MY GARAGE @ NORTHCREST

COMMERCIAL CONSTRUCTION DRAWINGS

My Garage @ Northcrest
Site Detail Plan
Site Details
El Paso County, Colorado

1 Detention Basin Cross Sections
C601 NOT TO SCALE

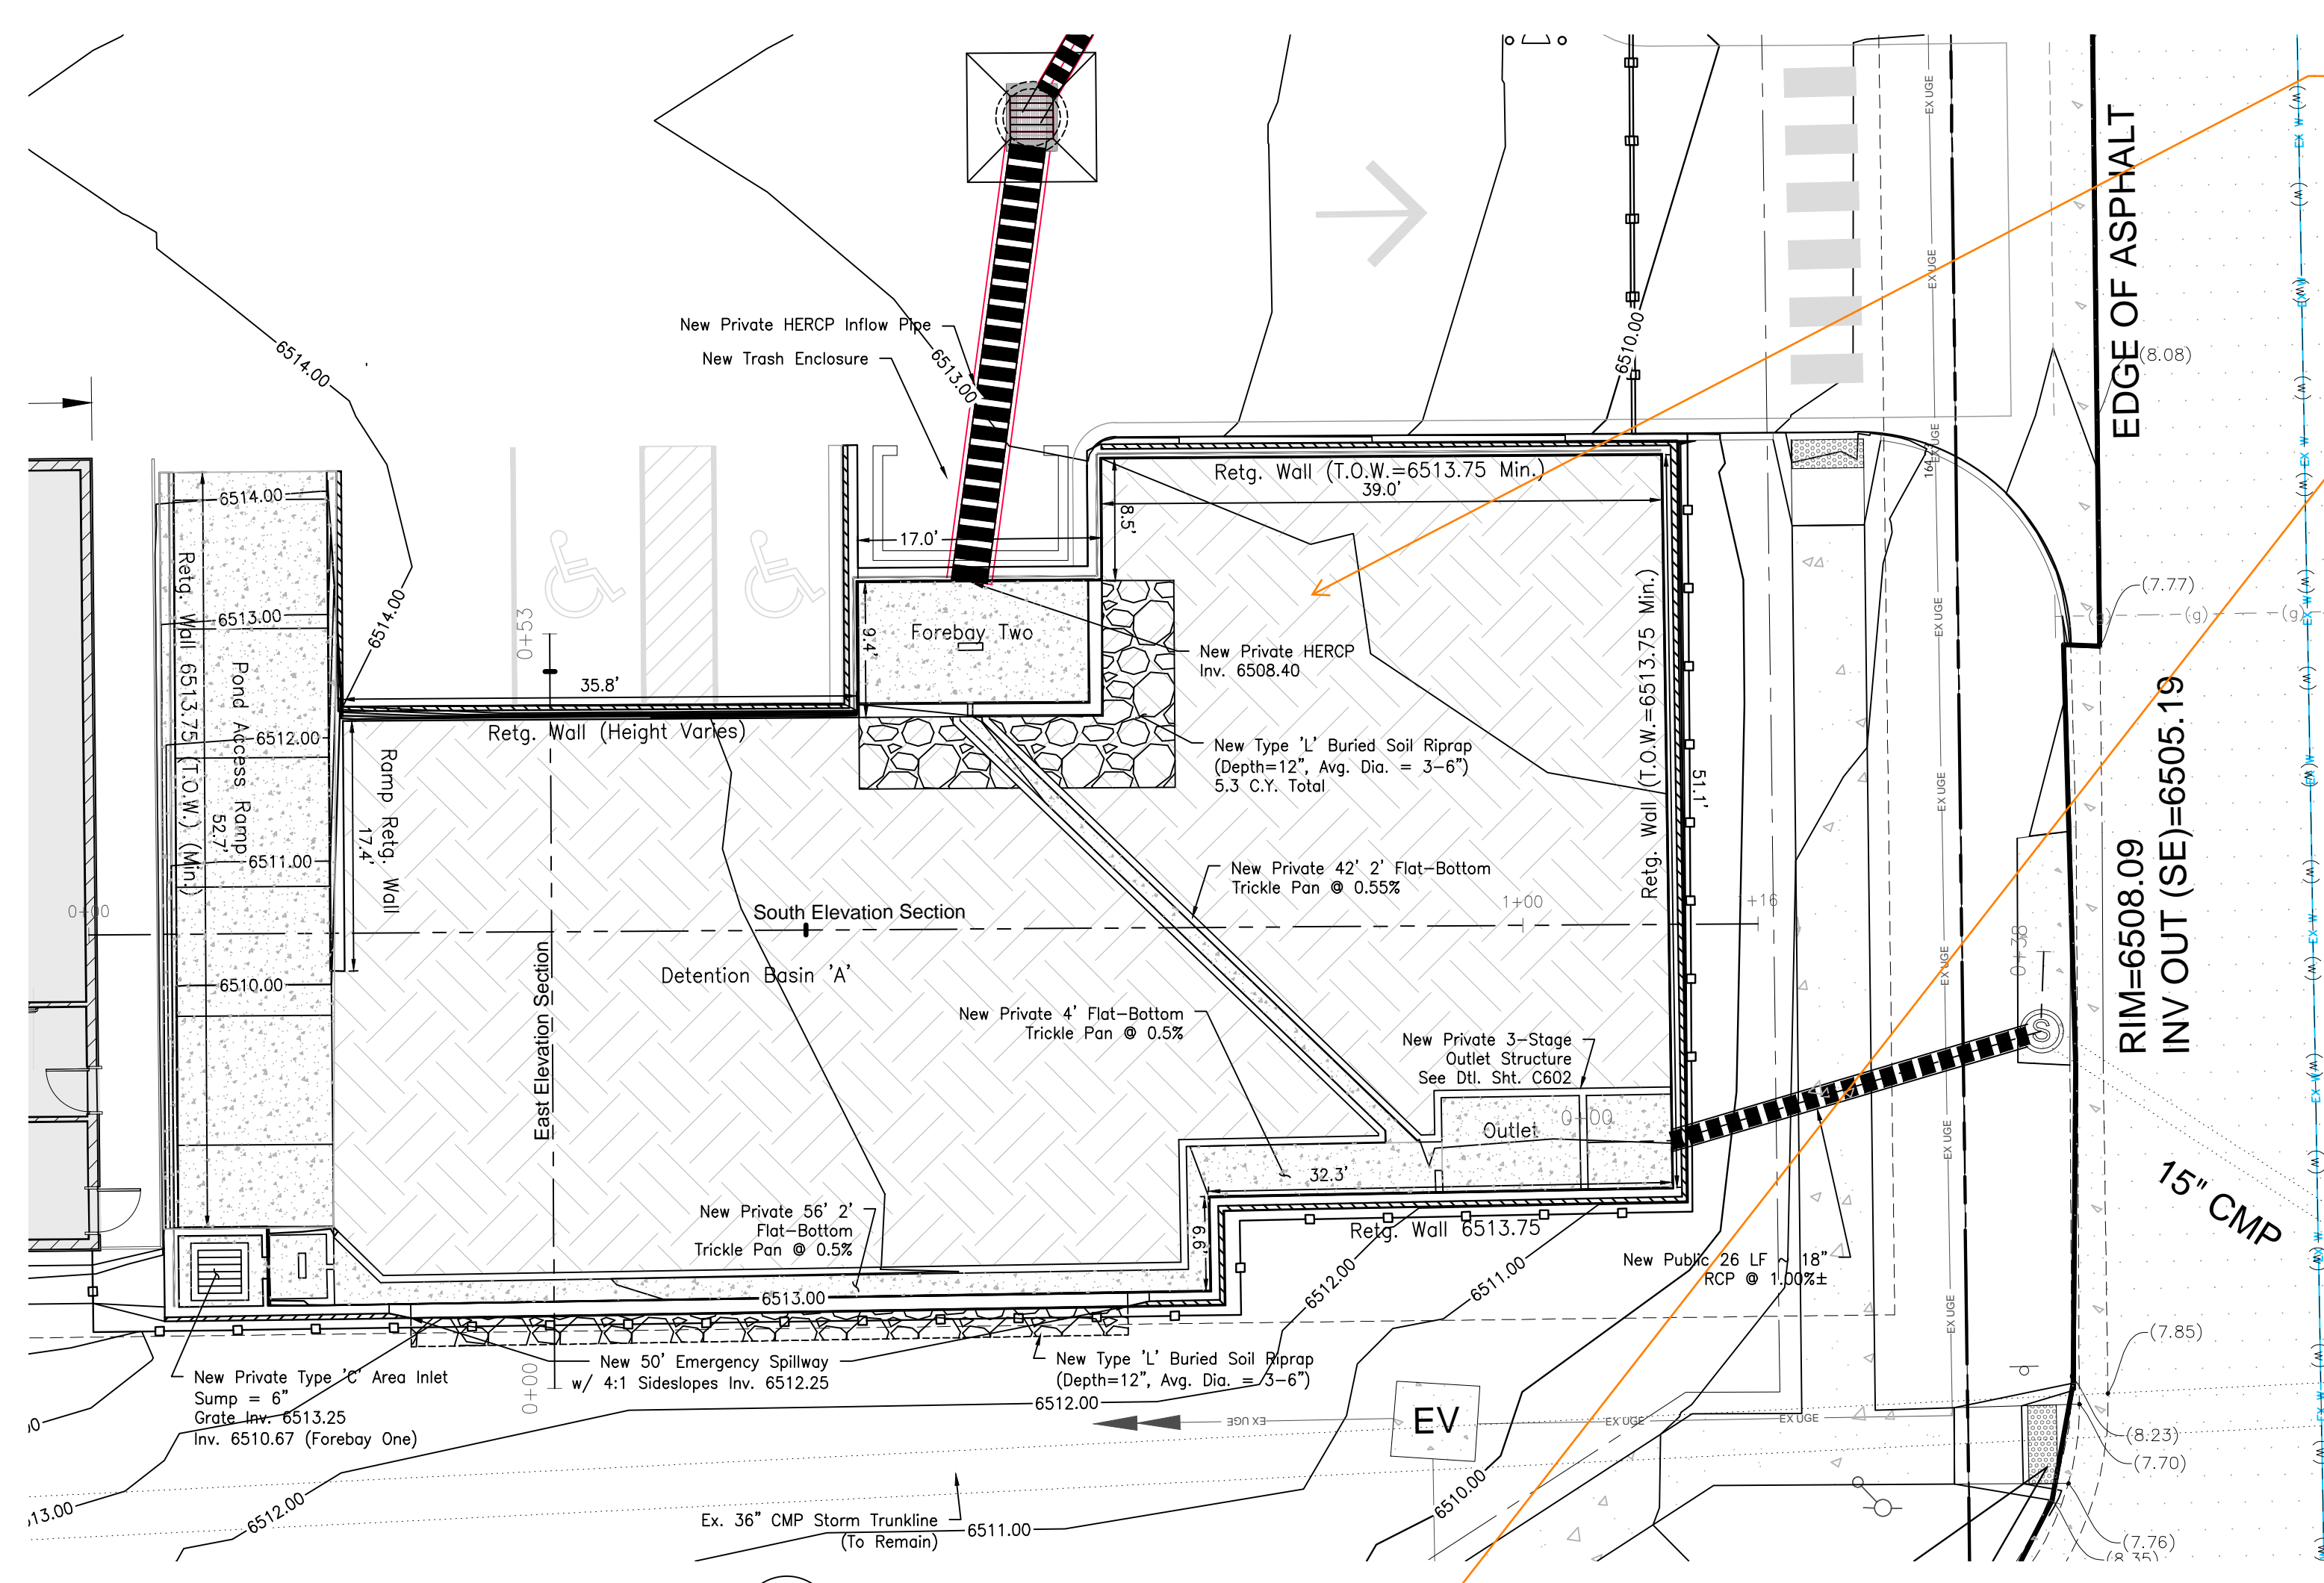
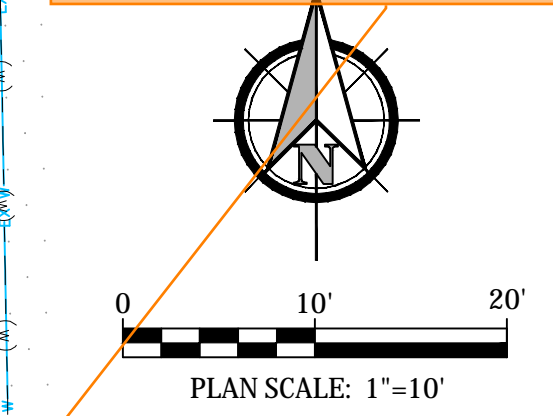
Unresolved Review 2 comment:
Pond bottom should have a minimum slope of 3%
to the trickle channel and micropool (USDCM Vol
3, detail T-5). Please adjust to minimize future
maintenance needs.

601 Emergency Spillway
1 NOT TO SCALE

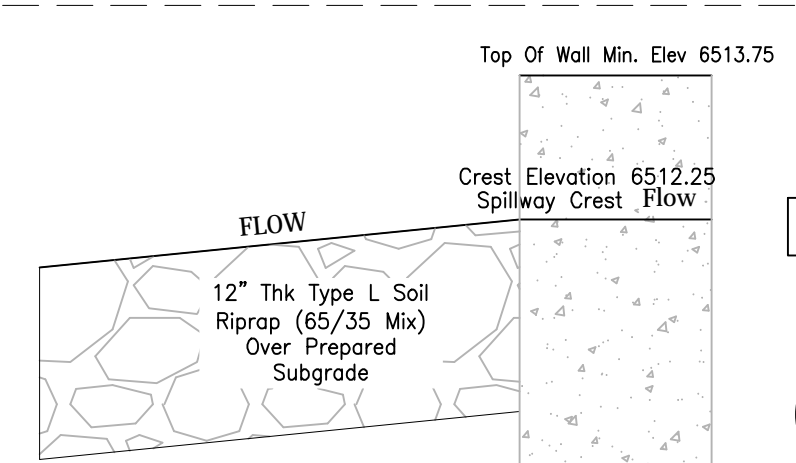
I'm not seeing the section markers for this section. Please show them.
